Addendum No. 01

TO: PLANS AND SPECIFICATIONS FOR STATE OF MISSOURI

Six New Full Service Cabins
Johnson's Shut-Ins State Park
Middle Brooke, MO
Project No: X2206-01

1 WINDOW DETAIL
A3.2 SCALE: 1 1/2" = 1'-0"

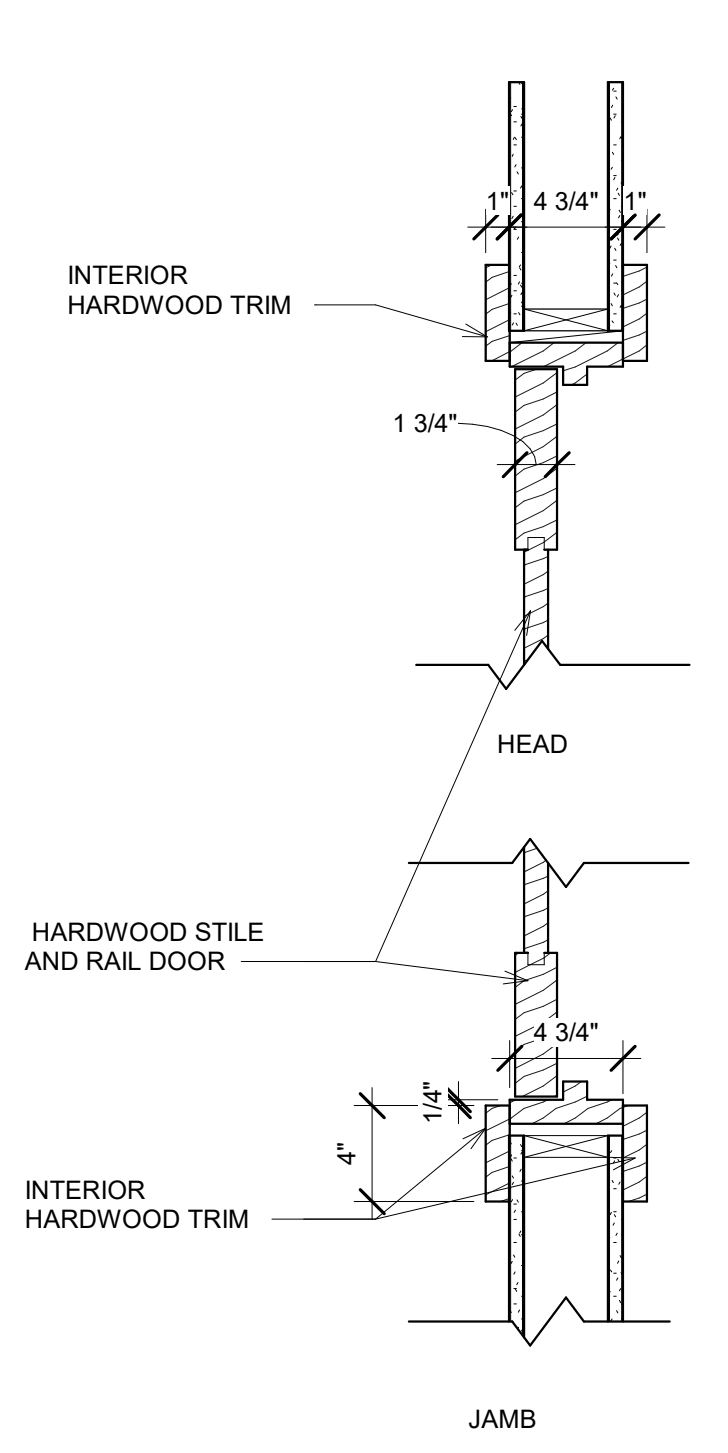
1. Sheet A3.2 – See Attached Revised Sheet A3.2
 - a. REVISE detail 1 to correct and add dimensioning.
2. Sheet S0.0 – See Attached Revised Sheet S1.0
 - a. REVISE Wood – Rough Carpentry Note D.4. as follows:

Answer: Floor sheathing shall extend under the wall bottom plate.
- i. Question: Exterior dimensions are confusing. For example: Sheet A1.0 detail 1 appears to show a dimension of 31’6” to the inside of the walls. A3.2 detail 1 gives a wall thickness of 5 3/8”. That makes the building 32’ 4 3/4”. The other side of the same of the same drawing shows (4) 8’ dimensions (32’) outside to outside. Detail 2 on S1.0 shows 4 piers 8’ on center. That would be 32’ from center to center of the outside piers and the 6 x 12 beam. The beam appears to line up with the outside of the stud so the overall dimension would be 32’ 6”.

Answer: The 1 1/2” insulated exterior panel dimension is not correct and will be revised from 1 1/2” to 2 1/8” in ADDENDUM 1. This will make the exterior wall 6 1/4” thick from inside face of drywall to the outside face of the R-6 insulated zip panel noted on keyed note F13 and keyed to the wall sections on sheet A3.0. The overall dimension should be 32’ 6” as noted above.

SHEET NUMBER
S1.0

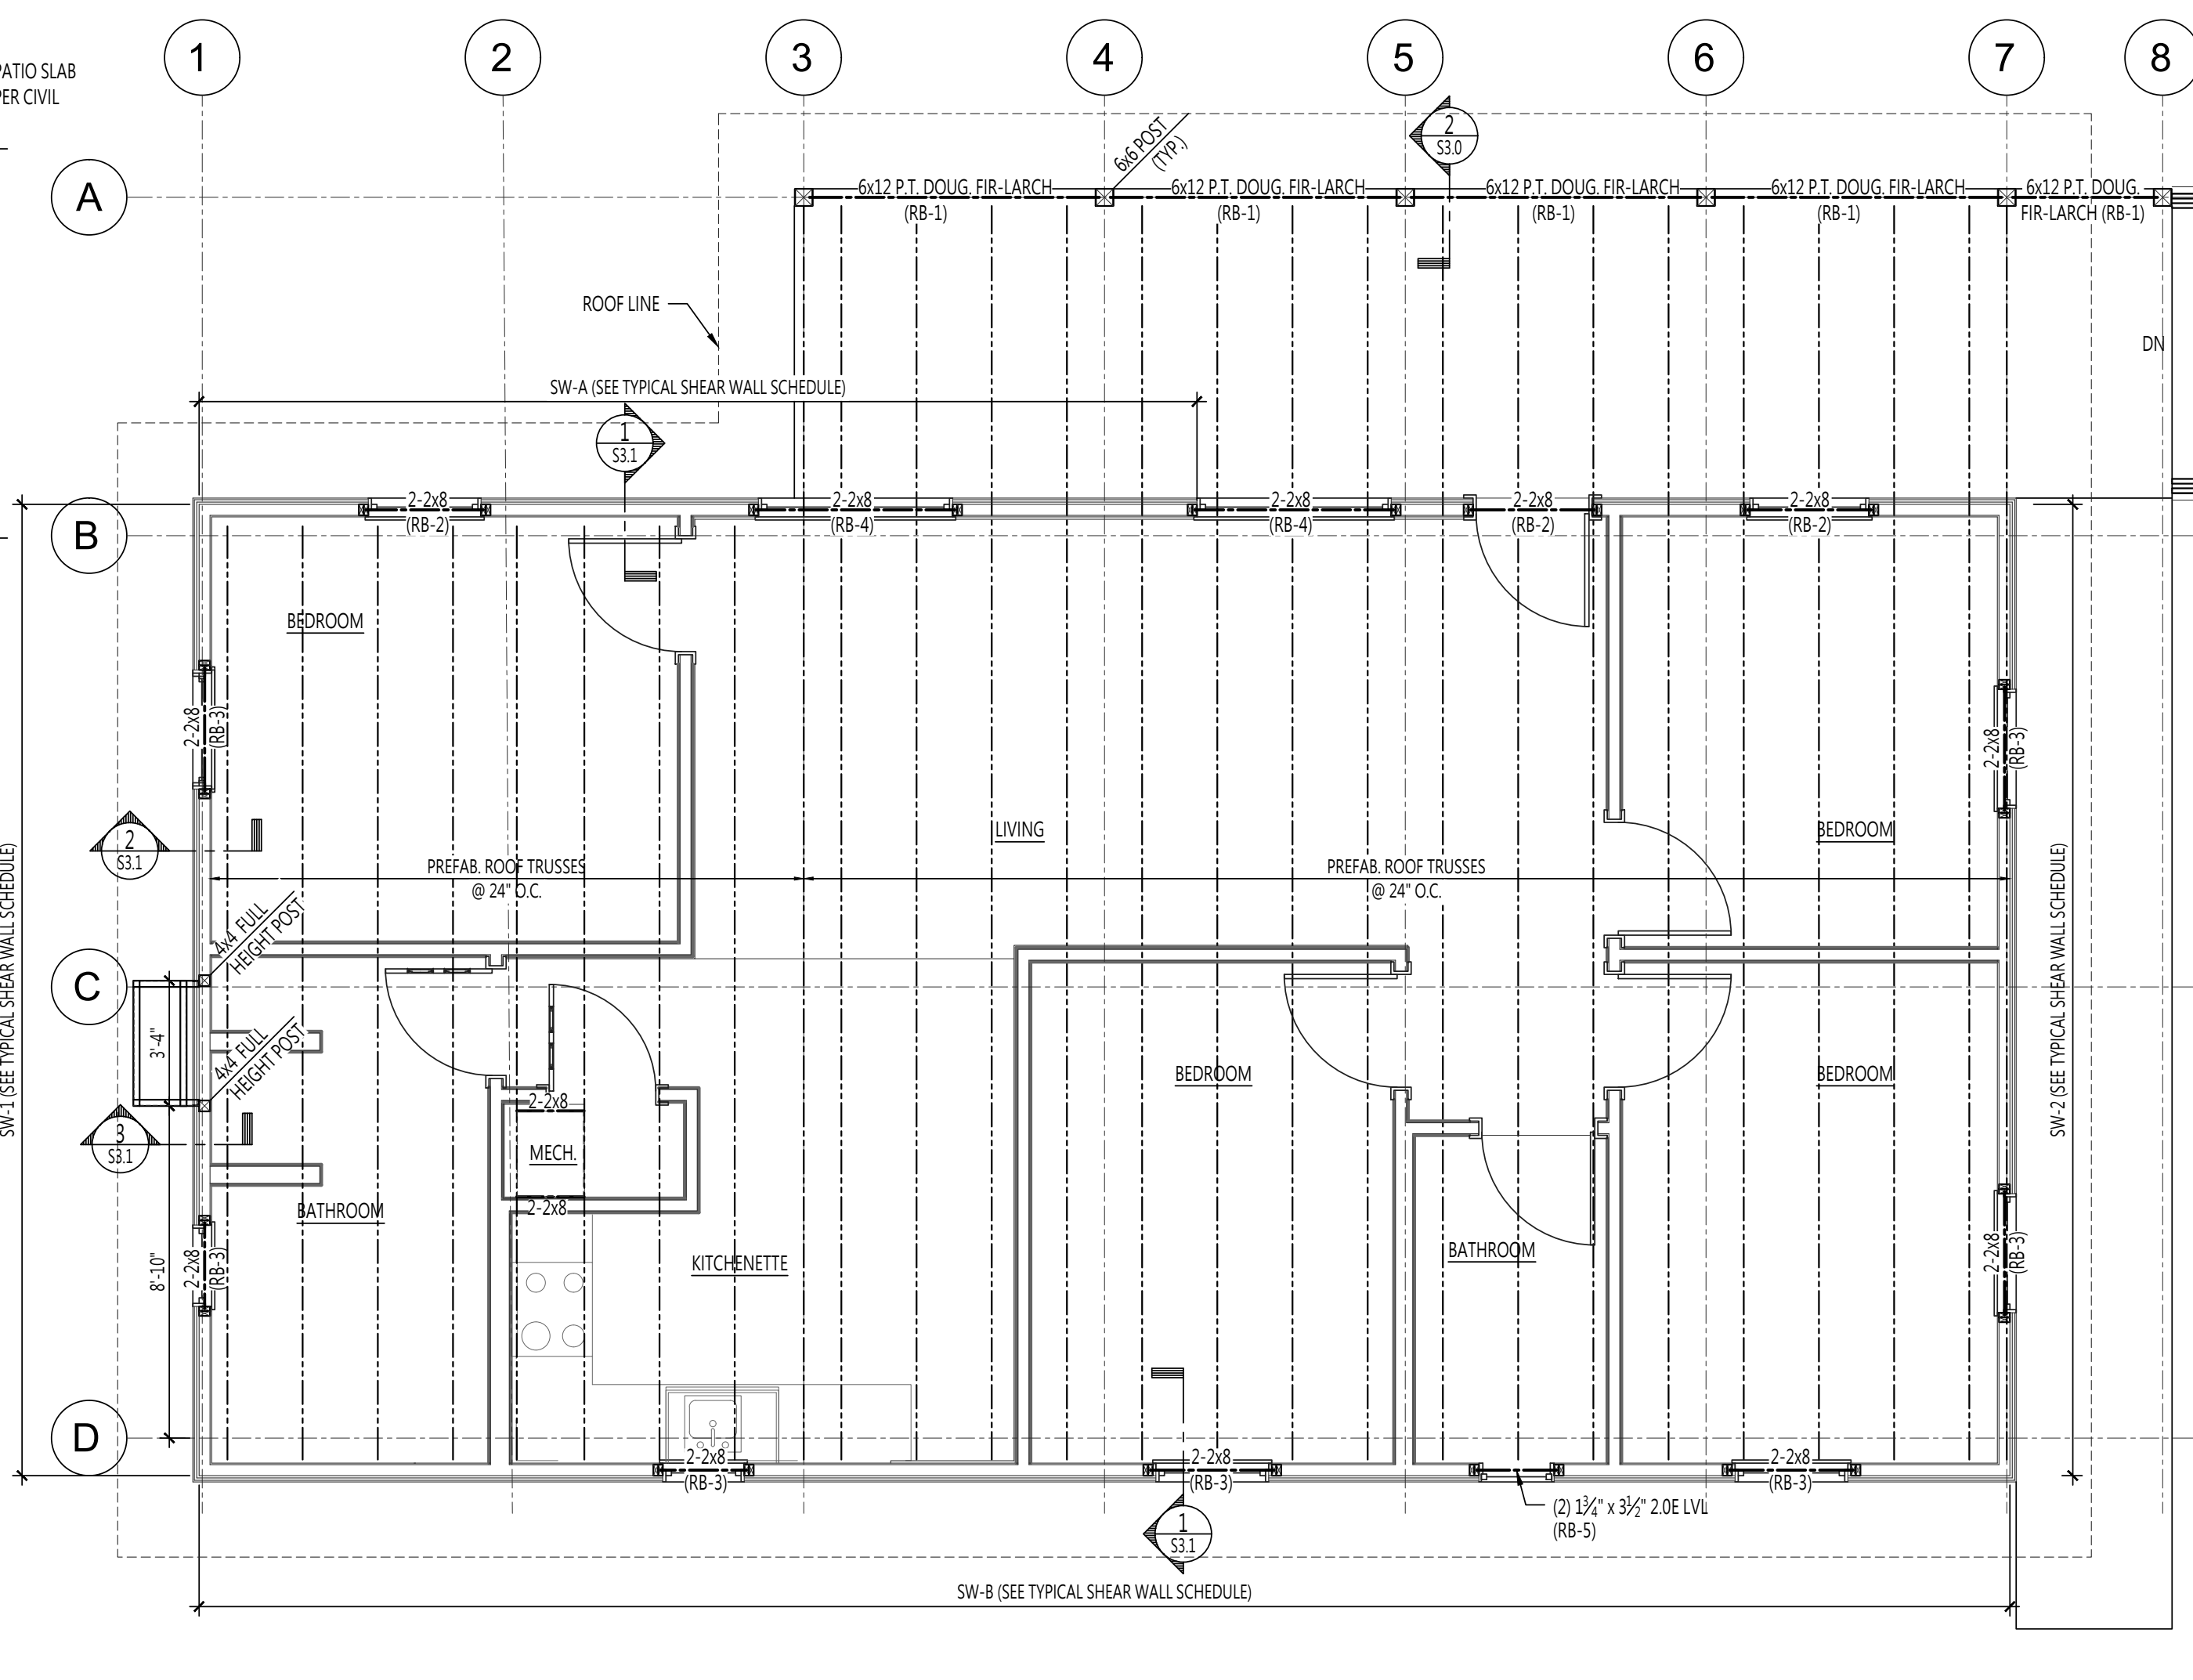
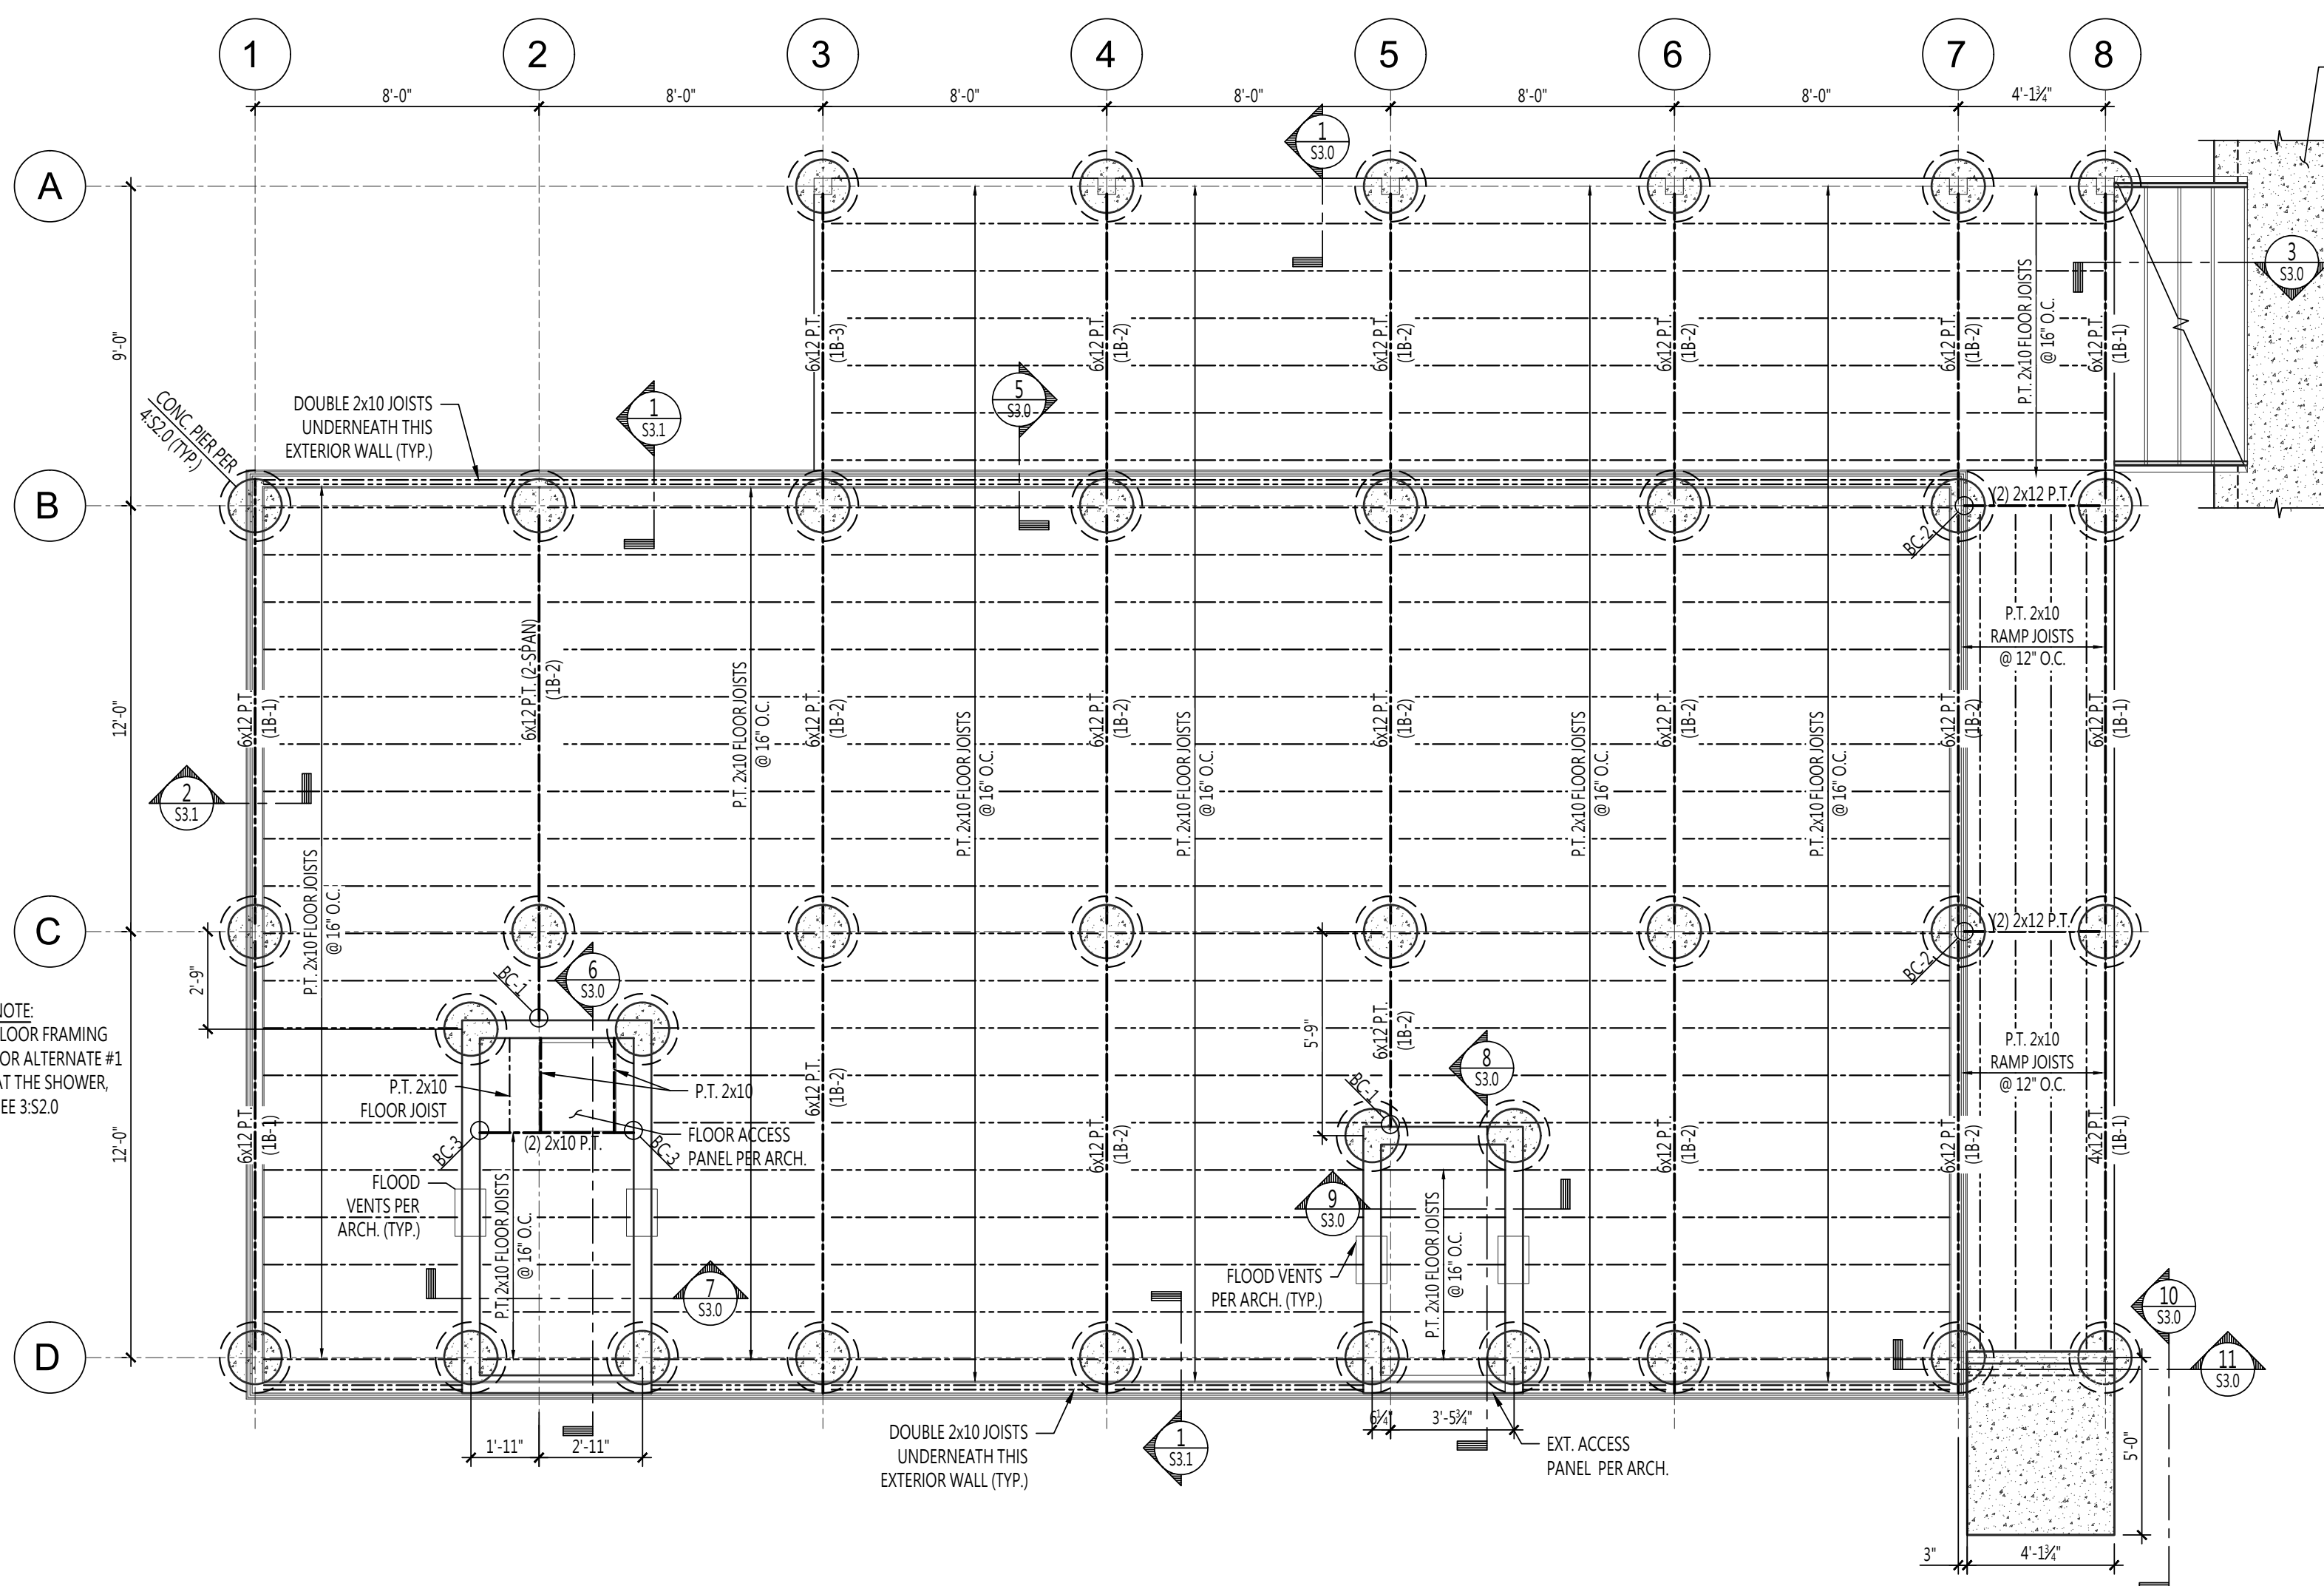
ROOF SHEATHING MAY BE EXPOSURE 1
3. Sheet S1.0 – See Attached Revised Sheet S1.0
 - a. REVISE General Concrete Foundation Note 12 as follows:

- d. Question: The Geotech report calls for 2' over excavation and 2' beyond edges. Structural drawings do not indicate that.
Answer: Per the Geotechnical Report – Addendum 1 letter of June 22, 2022, the piers shall “be extended to a depth of at least 4.5 feet below the adjacent ground surface.” Note 12 under General Concrete Foundation Notes on sheet S1.0 has been updated to reflect. Detail 4/S3.0 accurately reflects this.

ALL FOOTINGS TO EXTEND TO A MINIMUM OF 4.5 FEET BELOW GRADE,
UNLESS NOTED OTHERWISE.
4. Sheet S2.0 – See Attached Revised Sheet S2.0
 - a. REVISE General Concrete Foundation Note 12 as follows:

11 SECTION AT RAMP
SCALE: 3/4"=1'-0"

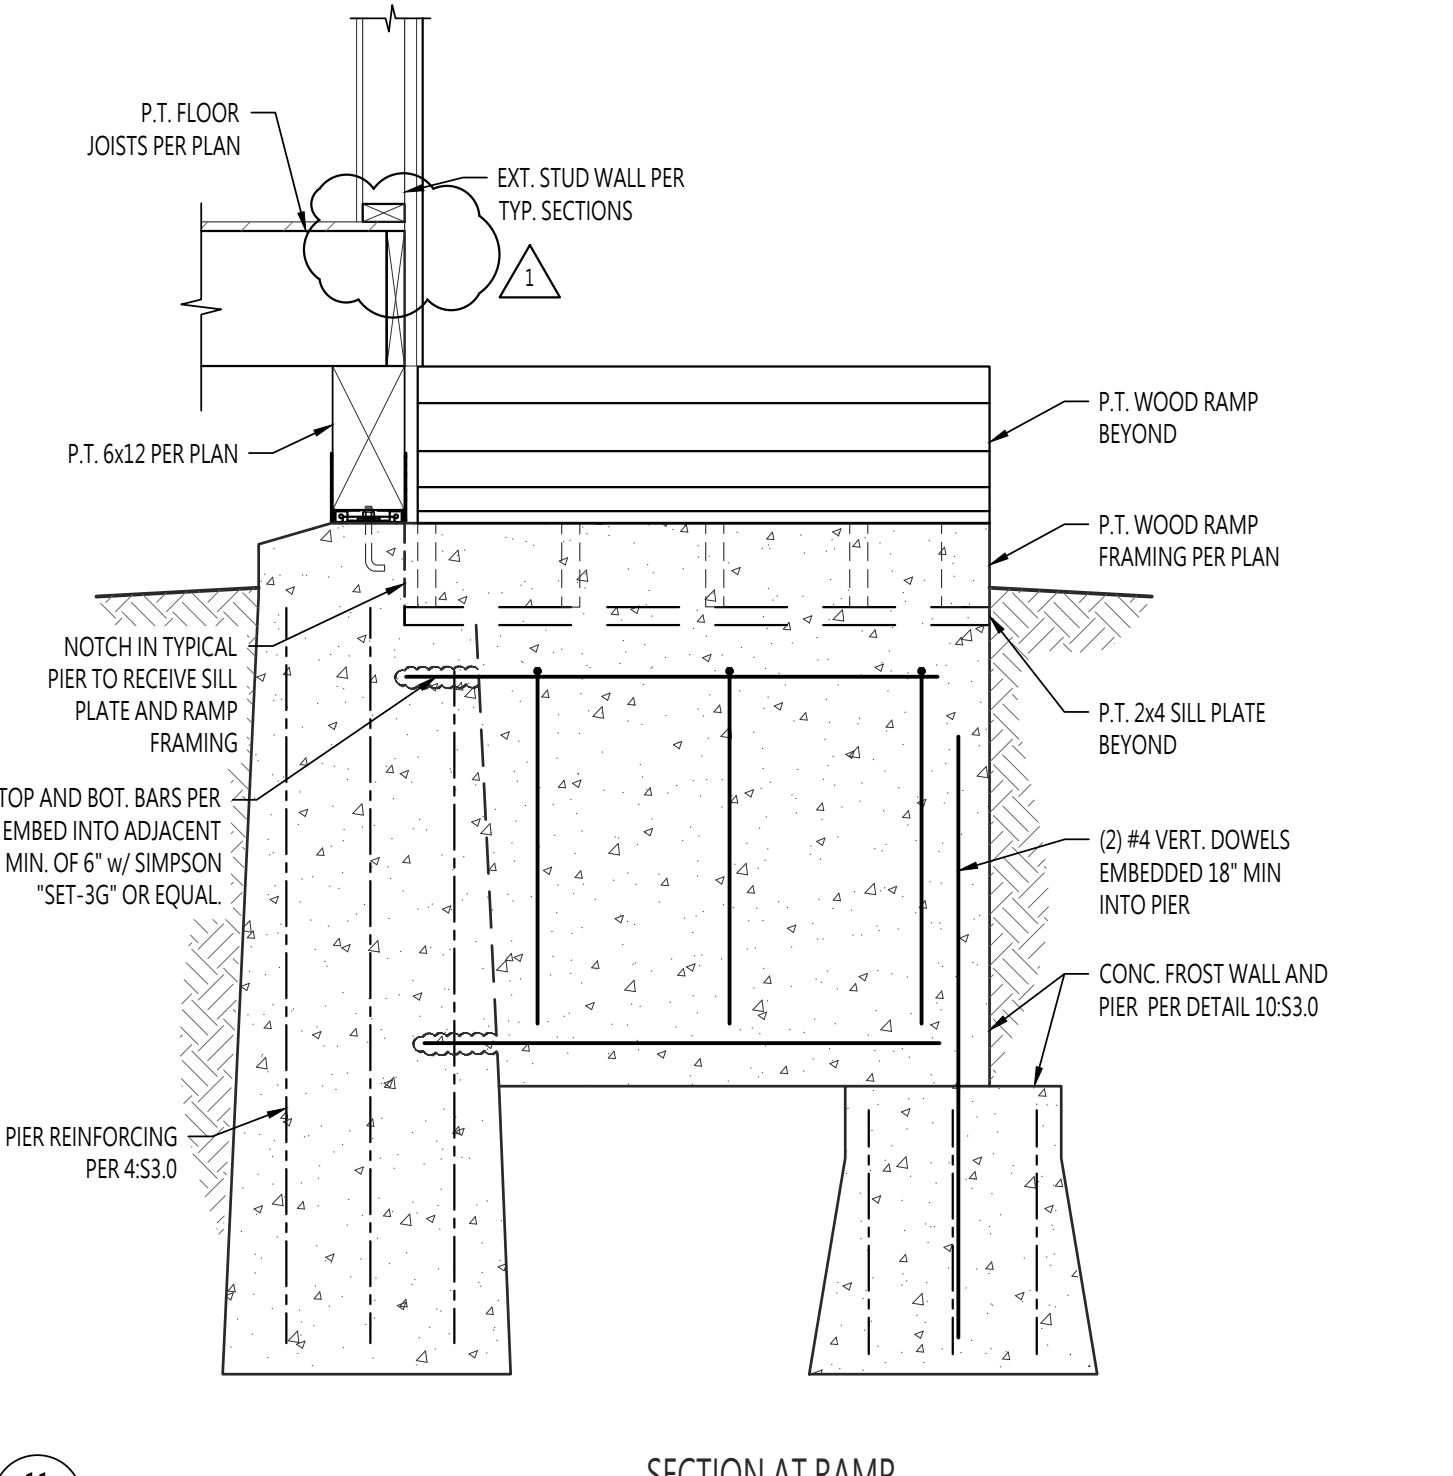
ALL FOOTINGS TO EXTEND TO A MINIMUM OF 4.5 FEET BELOW GRADE,
UNLESS NOTED OTHERWISE.
5. Sheet S3.0 – See Attached Revised Sheet S3.0
 - a. REVISE Detail 11 to indicate floor sheathing extending below sill plate.
6. Sheet S3.1 – See Attached Revised Sheet S3.1
 - a. REVISE Detail 2 to indicate floor sheathing extending below sill plate.
 - b. REVISE Detail 2 to indicate 2 – 2” x 4” Top Plate.
